[Docket No. FAA–2009–1253; Directorate Identifier 2009–NM–080–AD; Amendment 39–16629; AD 2011–06–05]

Airworthiness Directives; The Boeing Company Model 737–600, –700, –700C, –800, –900, and –900ER Series Airplanes

ACTION: Final rule.

**Figure 1**

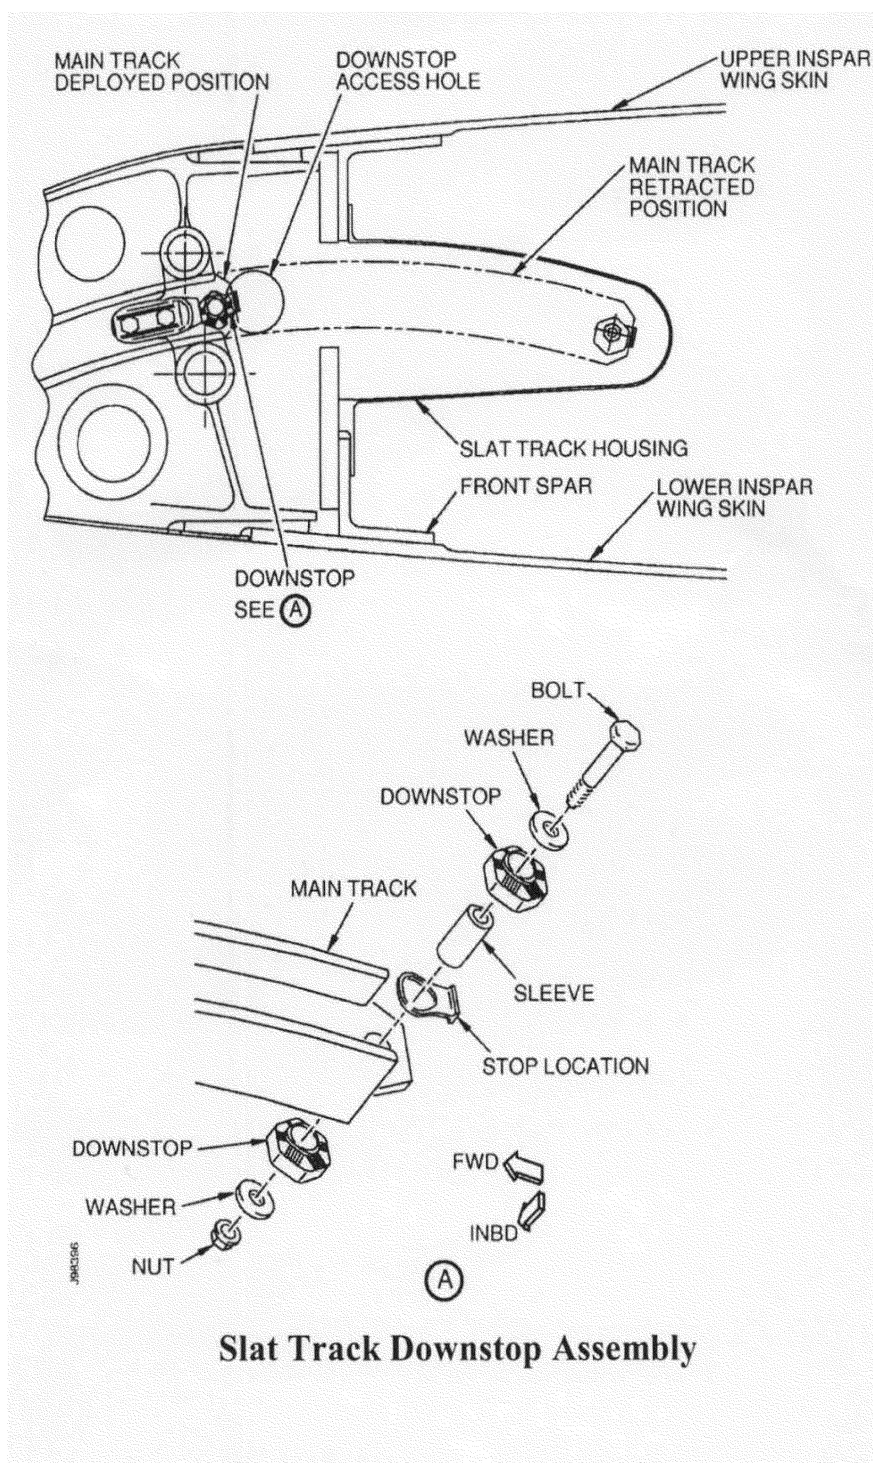
(g) Within 10 days after September 26, 2007 (the effective date of AD 2007–18–52): Do a detailed inspection or a borescope inspection of each main slat track downstop assembly to verify proper installation of the slat track hardware (*i.e.*, the bolt, washers, downstops, stop location, and nut shown in Figure 1 of Boeing Service Letter 737–SL–57–084–B, dated July 10, 2007, and in this AD). Proper installation of the sleeve need not be confirmed, and the stop location part may be installed on either the inboard or the outboard side of the slat track. If any part is missing or is installed improperly, before further flight, install a new or serviceable part using a method approved in accordance with the procedures specified in paragraph (j) of this AD; and do a detailed inspection of the inside of the slat can for foreign object debris (FOD) and damage. Before further flight, remove any FOD found and repair any damage found using a method approved in accordance with the procedures specified in paragraph (j) of this AD. Verify proper installation; install a new or serviceable part; and inspect for damage and FOD, and remove FOD and repair damage; in accordance with a method by approved by the Manager, Seattle Aircraft Certification Office, FAA; or in accordance with Boeing Multi Operator Message Number 1–523812011–1, issued August 25, 2007, or 1–527463441–1, issued August 28, 2007. Repeat the actions required by paragraph (g) of this AD thereafter at intervals not to exceed 3,000 flight cycles.
